# Ventura County Community College District

DATE: April 30, 2024  
TO: All Bidders  
FROM: David Cienfuegos, Purchasing Specialist  
SUBJECT: Addendum 1 – Bid 670, Oxnard College LA-7 Classroom Renovation

**OXNARD COLLEGE STEM CLASSROOM ALTERATION**  
4000 S ROSE AVE. OXNARD, CA 93033  
**ROOF PLAN & SECTIONS**

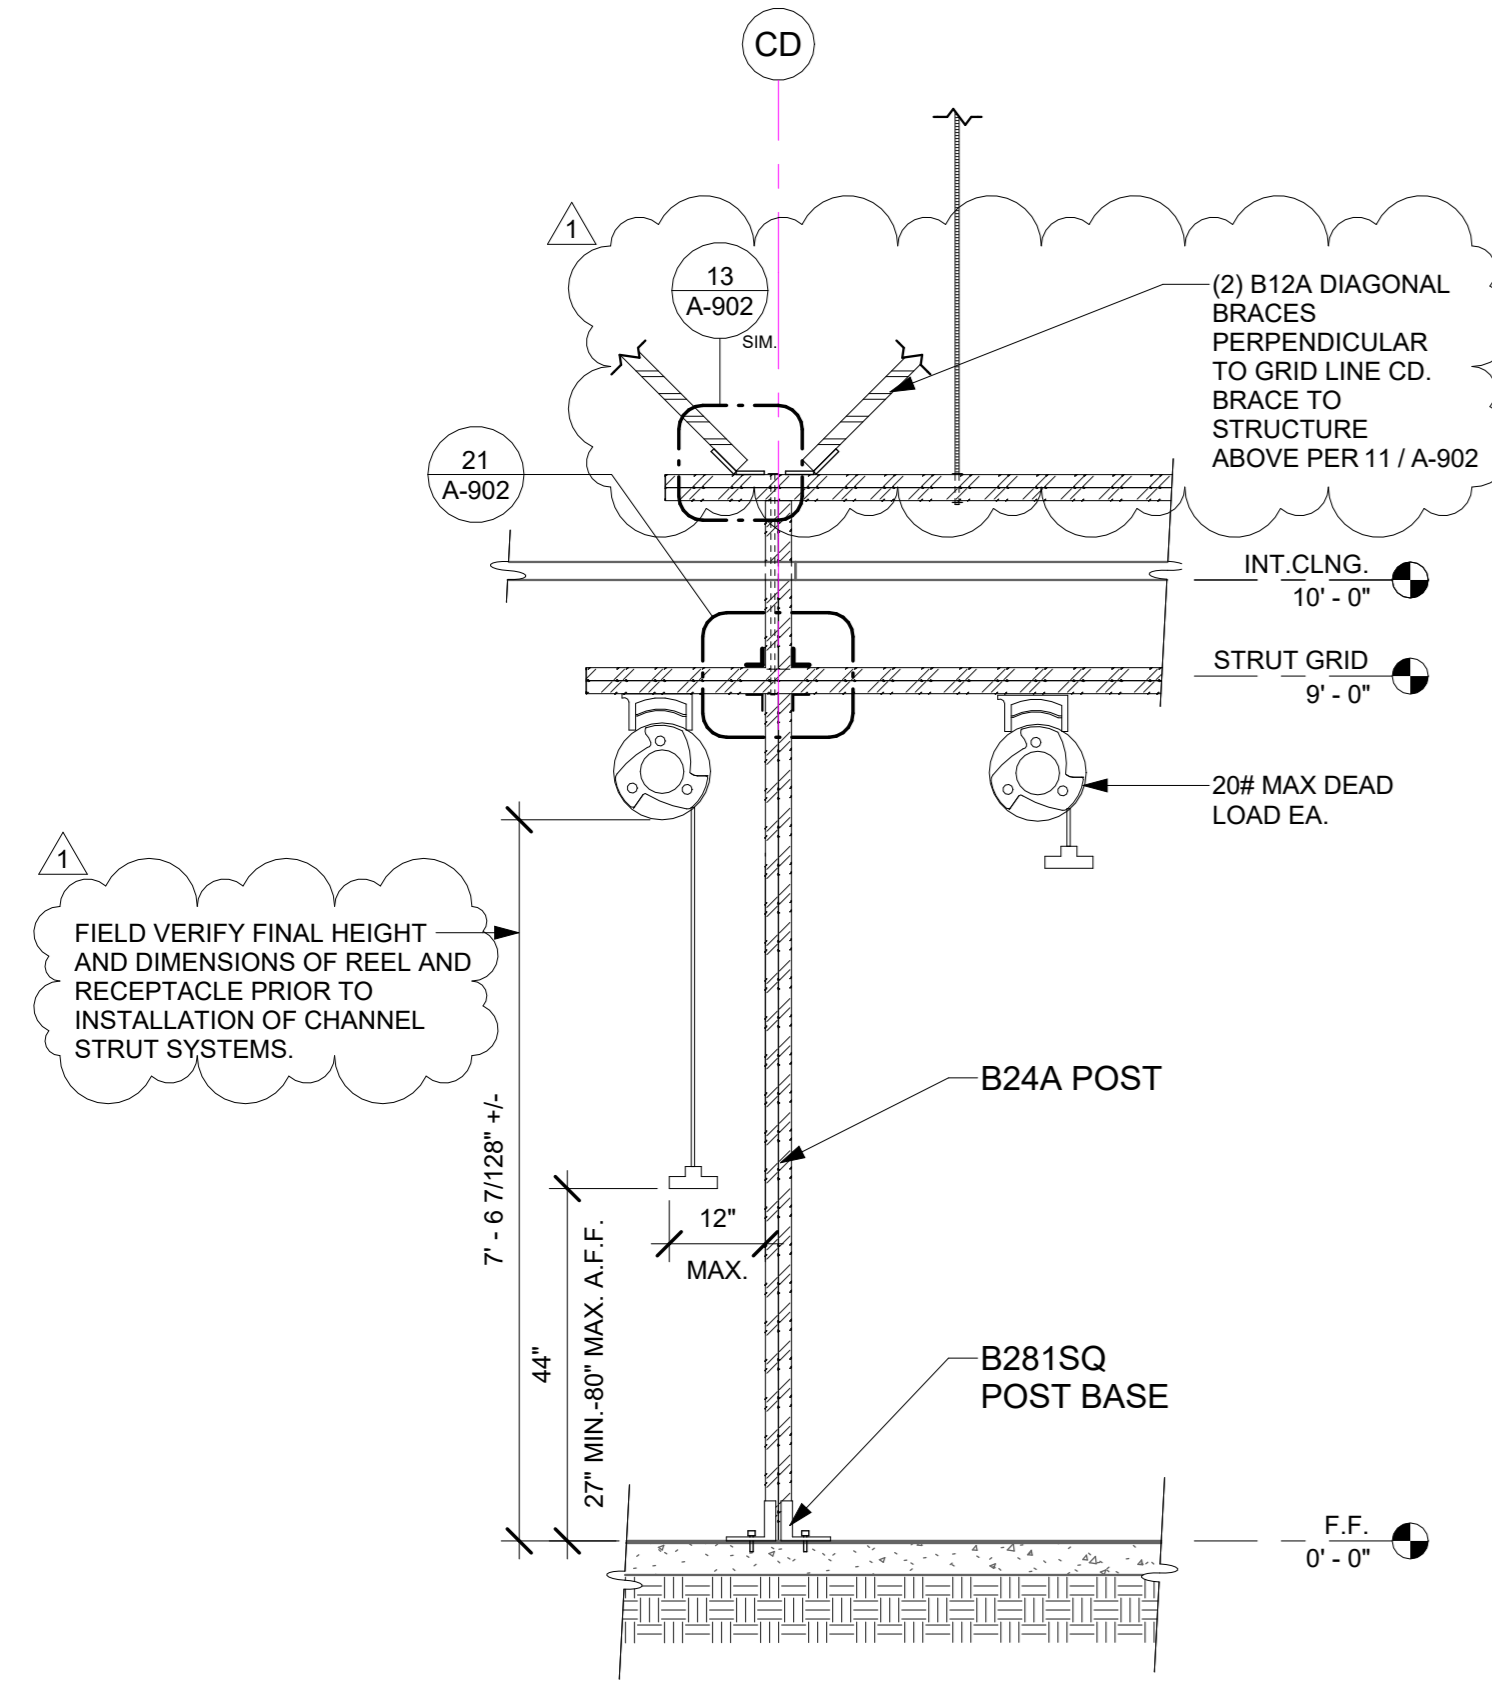
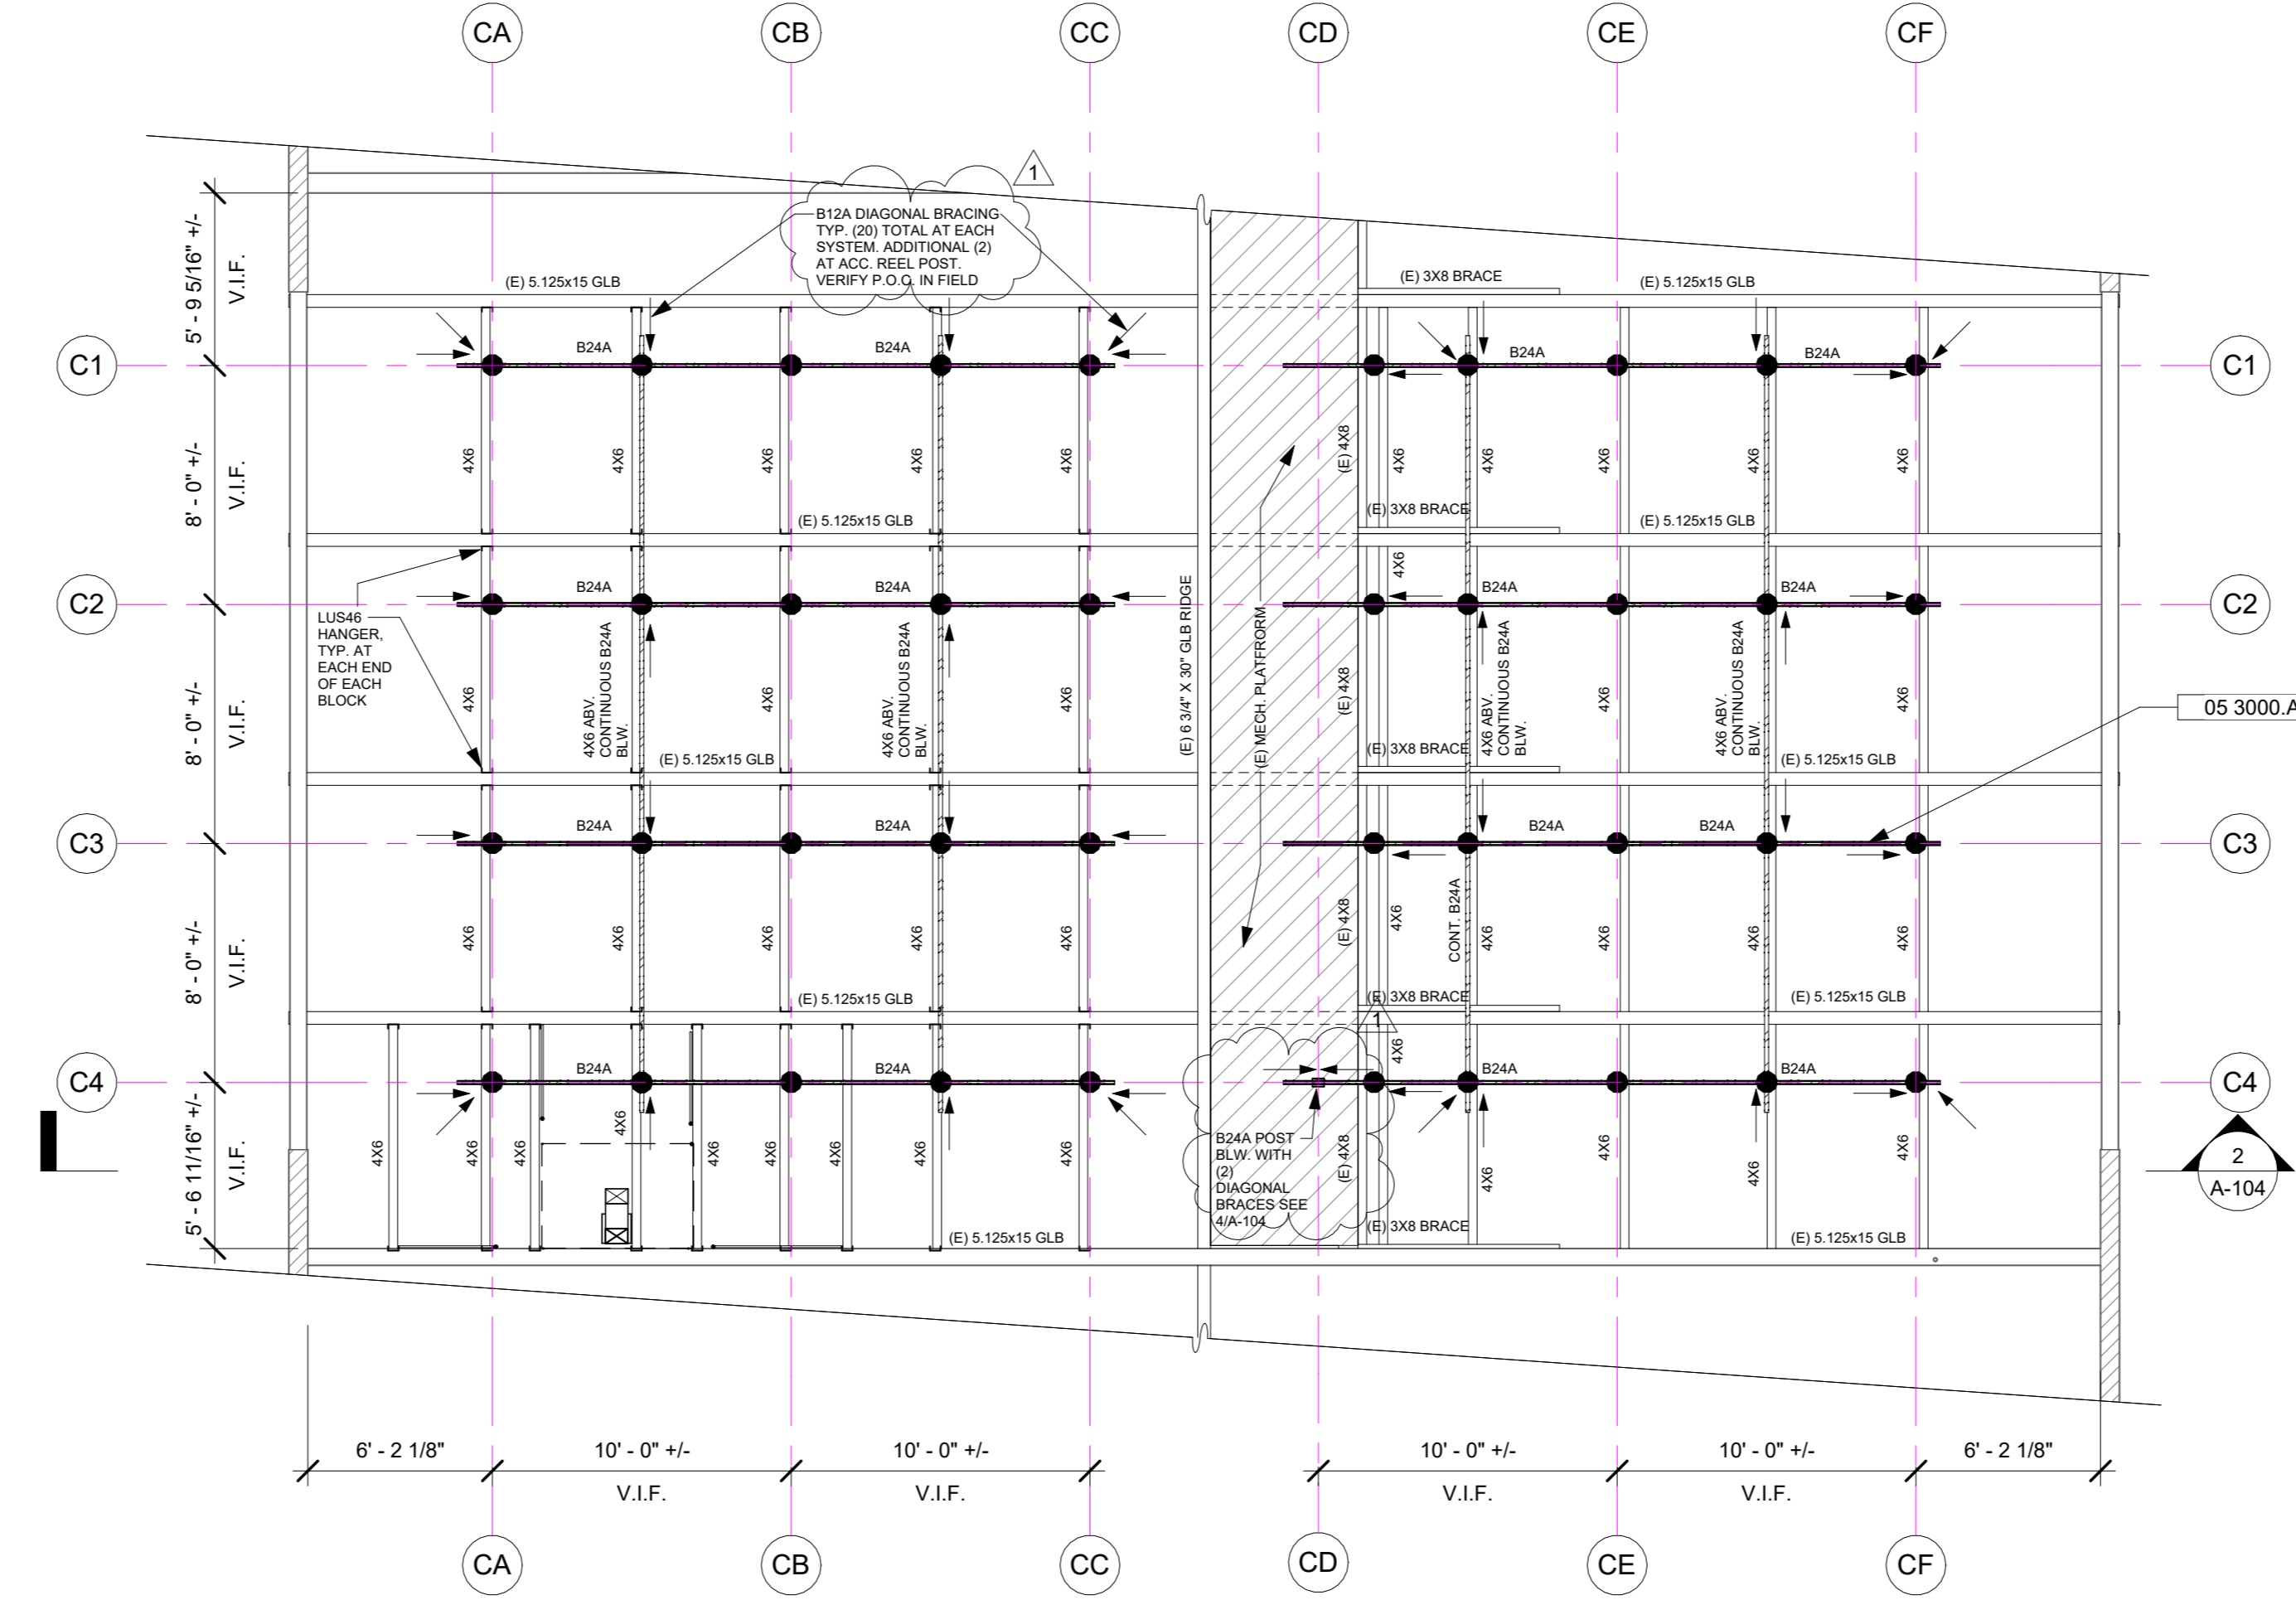
- A. Added notes to all drawing views on sheet
